Item 7 - LATE ADDITION

CALIFORNIA REGIONAL WATER QUALITY CONTROL BOARD
LAHONTAN REGION

Meeting of February 11, 2015
Apple Valley, South Lake Tahoe, Rosamond, Truckee

**PROPOSED BASIN PLAN AMENDMENT TO REMOVE THE MUNICIPAL AND
DOMESTIC SUPPLY (MUN) BENEFICIAL USE DESIGNATION FROM CERTAIN
GROUND WATERS BENEATH NAVAL AIR WEAPONS STATION CHINA LAKE,
KERN, INYO, AND SAN BERNARDINO COUNTIES**

Figure 2-2

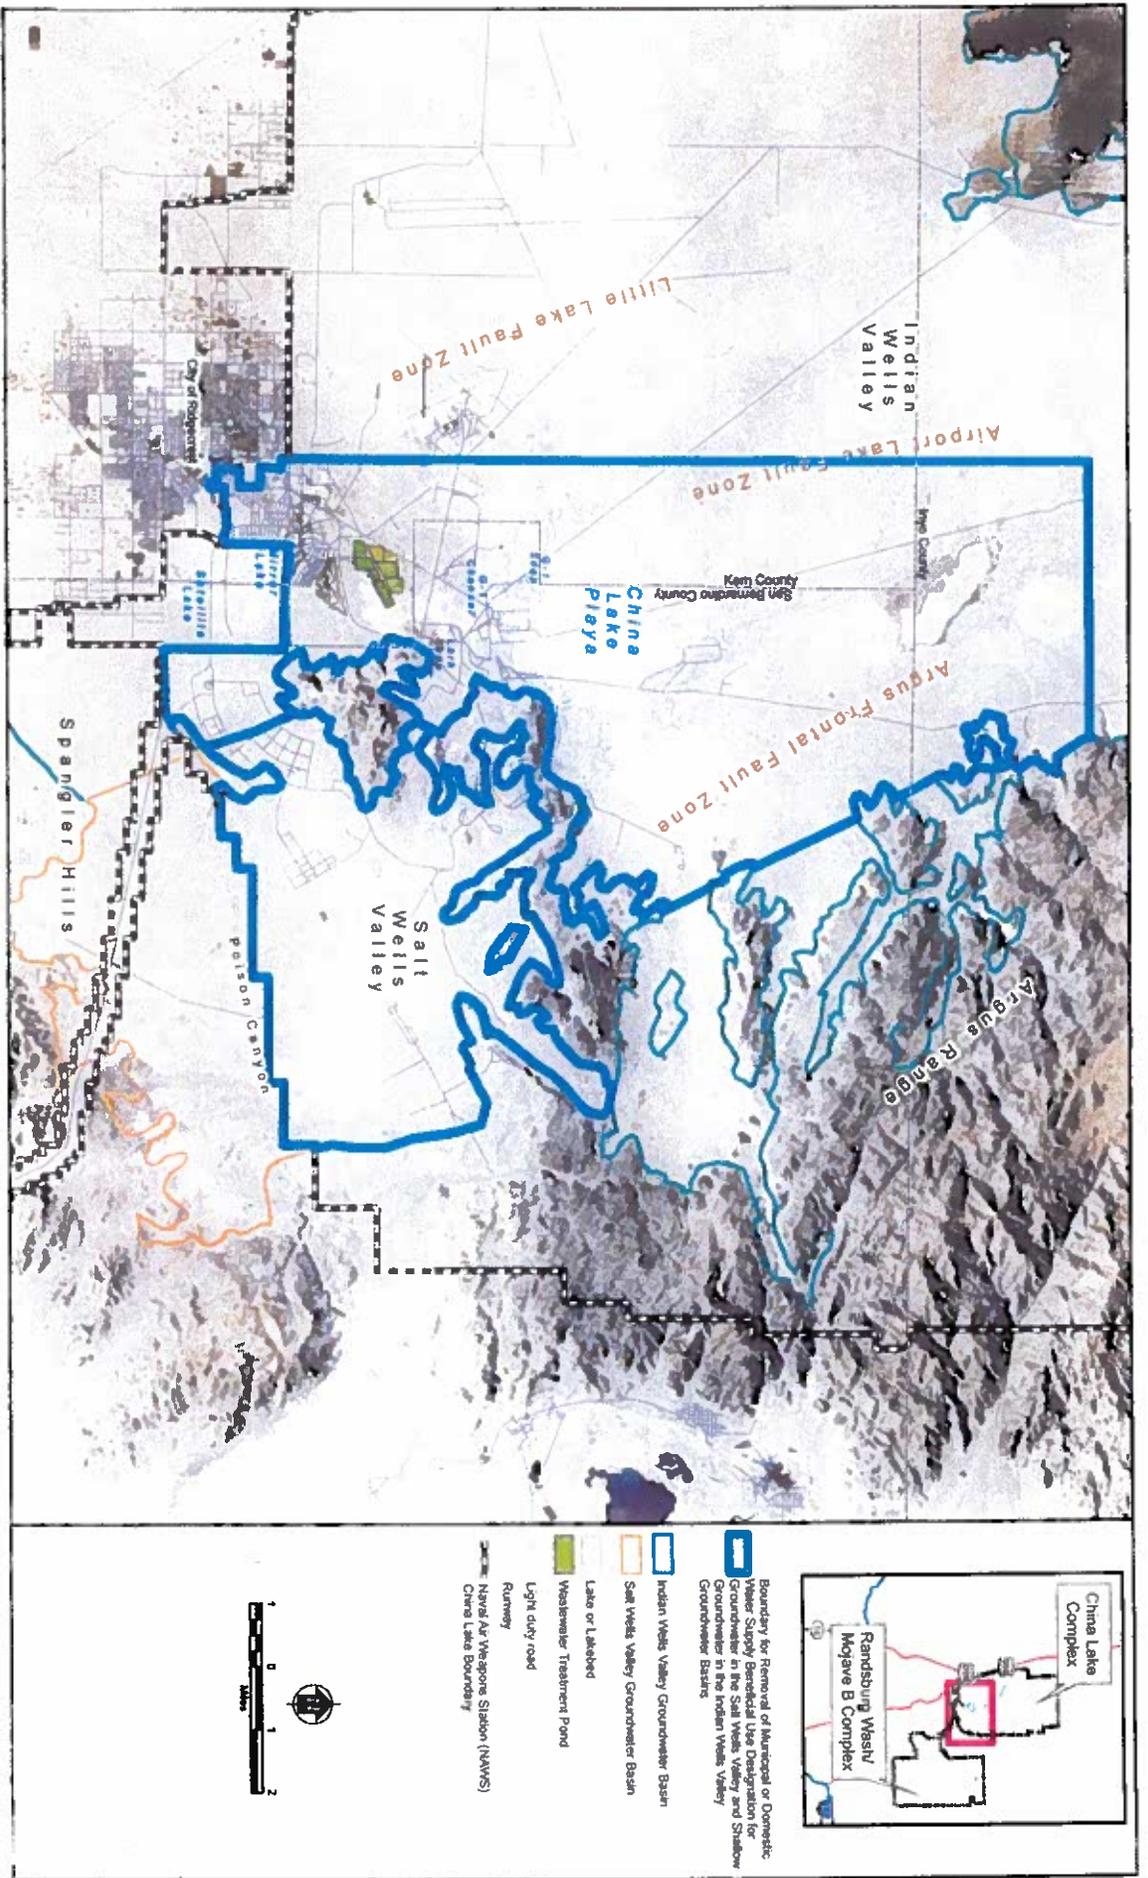
Please insert the attached Figure 2-2 to follow the Resolution as Bates stamp 7-8.5.

A. Add Figure 2-2 after the Searles Valley Groundwater Basin Public Land Survey System description on page 2-54.

B. Add the following reference to the Public Land Survey System in the Resolution as 1.D. (and in the Basin Plan following Figure 2-2):

The area shown in Figure 2-2, within which the Municipal and Domestic Supply beneficial use does not apply to ground water, is as follows:

Salt Wells Valley Groundwater Basin No. 6-53 (as defined in the California Department of Water Resources Bulletin 118) except the southern boundary which is defined by the boundary of Naval Air Weapons Station China Lake. The Salt Wells Valley Groundwater Basin de-designation area includes all or portions of:

T26S, R41E (except Sections 35 and 36);

T26S, R42E, Sections 5, 6, 7, 8, 16, 17, 18, 19, 20, 21, 28, 29, 30; and

T25S, R42E, Sections 31 and 32, all referenced to MDB&M.

Indian Wells Valley Groundwater Basin No. 6-54 (as defined by California Department of Water Resources Bulletin 118) such that:

The western boundary runs northward from the northern portion of Section 34 (as defined by the boundary of Naval Air Weapons Station China Lake), T26S, R40E to the northwest corner of Section 21, T24S, R40E.

The northern boundary includes, from west to east: Section 21, T26S, R40E to the eastern boundary of Indian Wells Valley Groundwater Basin No. 6-54.

The eastern boundary is defined as the eastern boundary of Indian Wells Valley Groundwater Basin No. 6-54.

The southern boundary is defined by the boundary of Naval Air Weapons Station China Lake from the northern portion of Section 34, T26S, R40E, as defined by the boundary of Naval Air Weapons China Lake, excluding the east half of Section 26 and all of Sections 25 and 36, T26S, R40E to the Salt Wells Valley Groundwater Basin No. 6-53, exclusive of Section 25, east half of Section 26, and Sections 35 and 36, T26S, R40E.
